Part 1	Division 00, Procurement and Contract Requirements
Part 2	Technical Changes, Architectural, Structural and Civil
Part 3	Technical Changes, Mechanical, Electrical and Plumbing
Part 4	Drawing Changes, Architectural, Civil and Landscape
Part 5	Drawing Changes, Structural NOT USED
Part 6	Drawing Changes, Mechanical, Electrical and Plumbing
Part 7	Clarifications
Part 8	New Issues - List of Included Documents

TWIN TOWERS
MIDDLE SCHOOL

Additions & Alterations

ENLARGED CITY SCHOOL
DISTRICT OF MIDDLETOWN

E204.A

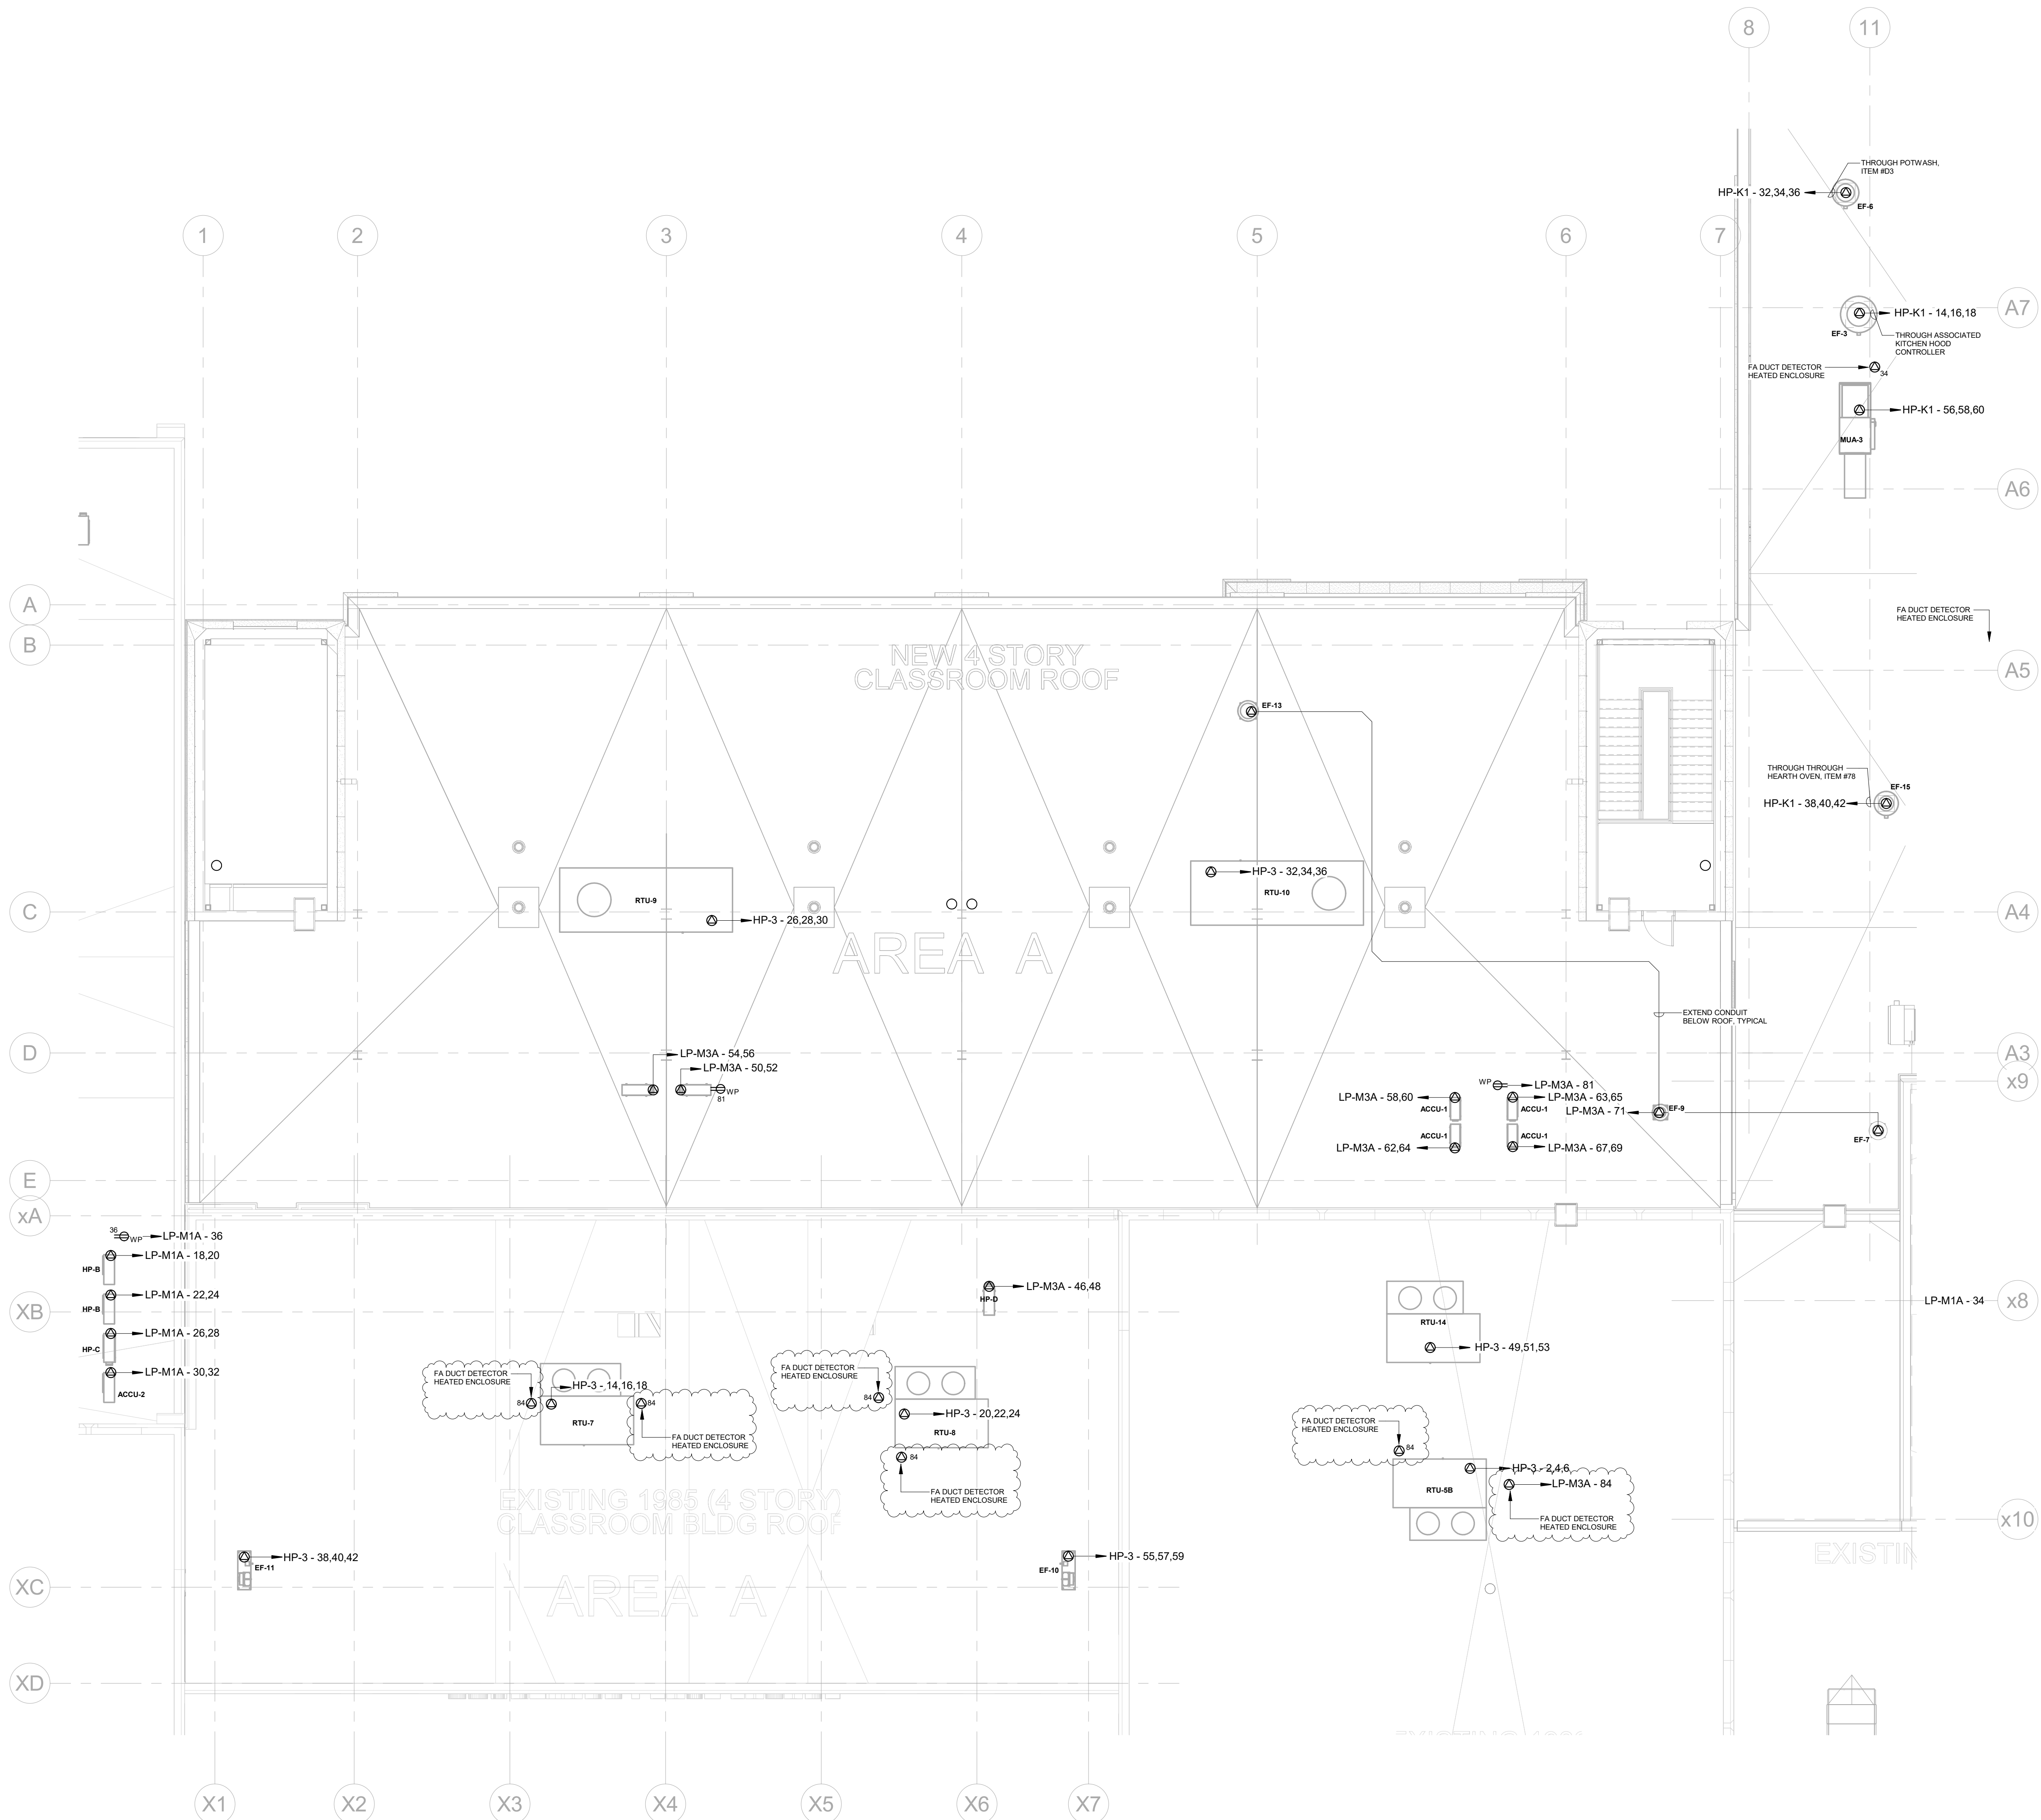
- 4) Drawing E204.A – Revise drawing to show branch circuitry to Fire Alarm duct detector heated enclosures.
- 5) Drawing E204.B – Revise drawing to show branch circuitry to Fire Alarm duct detector heated enclosures.

Sheet Number
E204.S

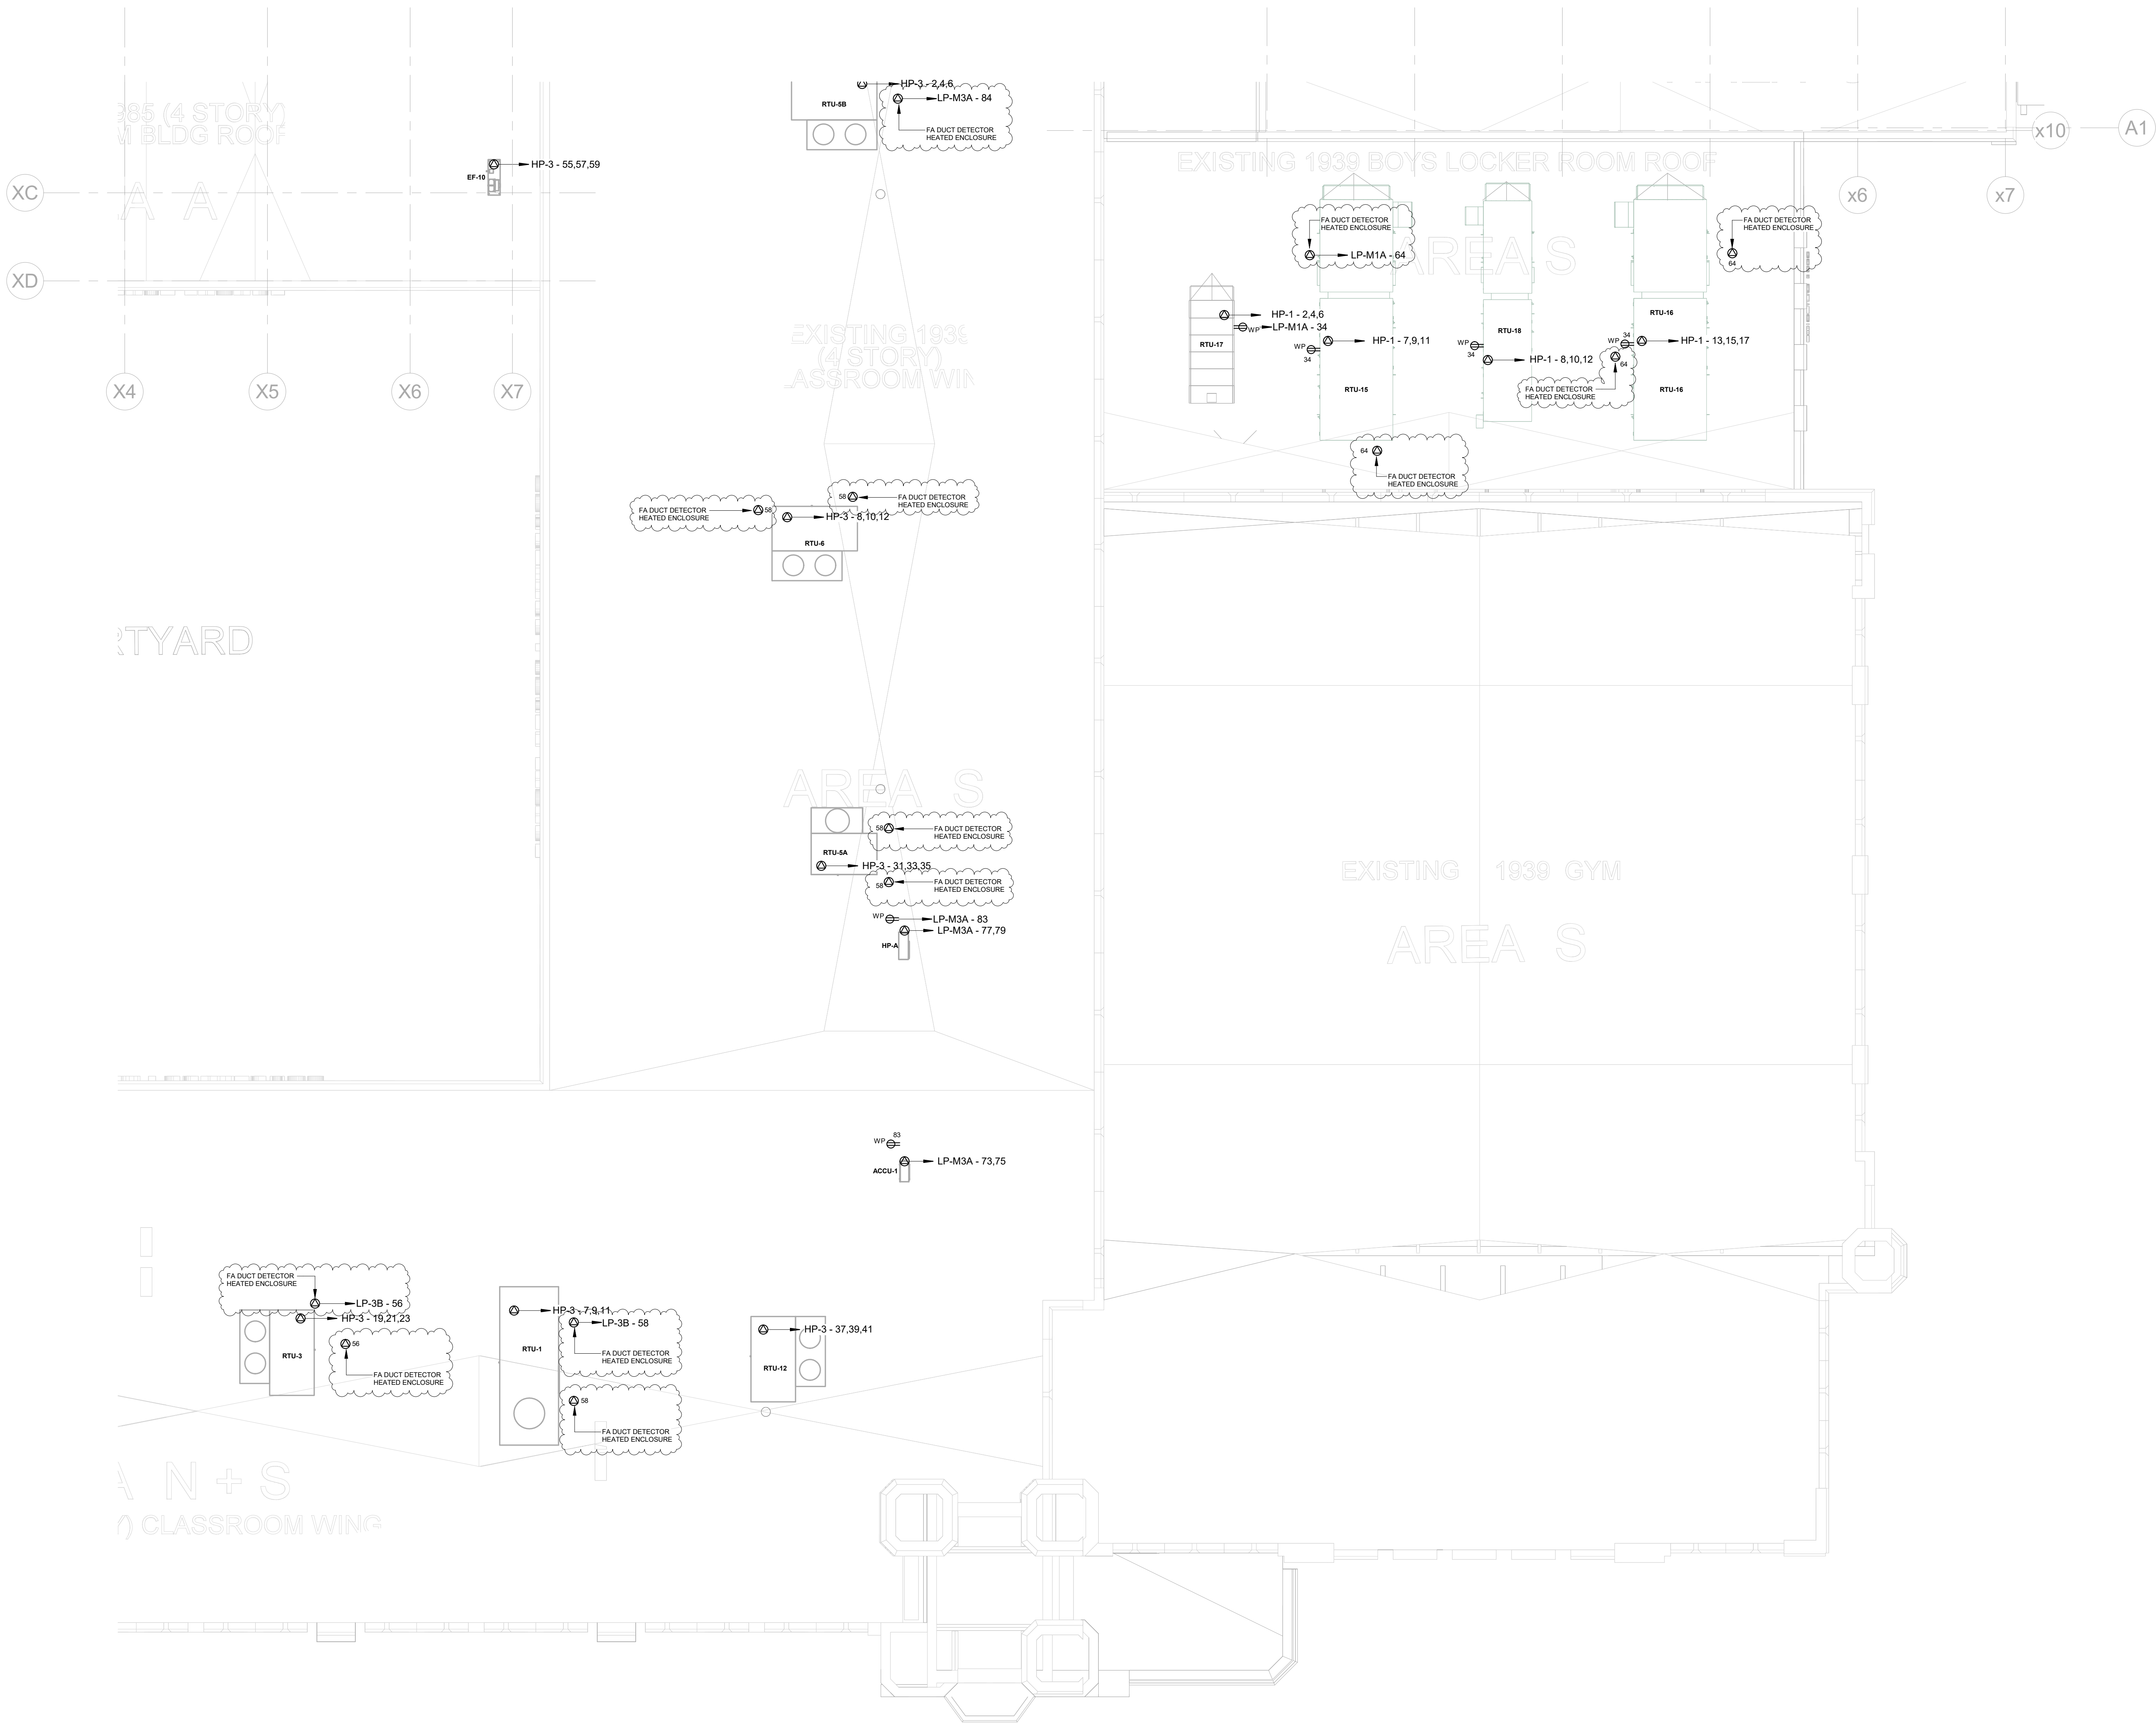
- 6) Drawing E204.N – Revise drawing to show branch circuitry to Fire Alarm duct detector heated enclosures.
- 7) Drawing E204.S – Revise drawing to show branch circuitry to Fire Alarm duct detector heated enclosures.
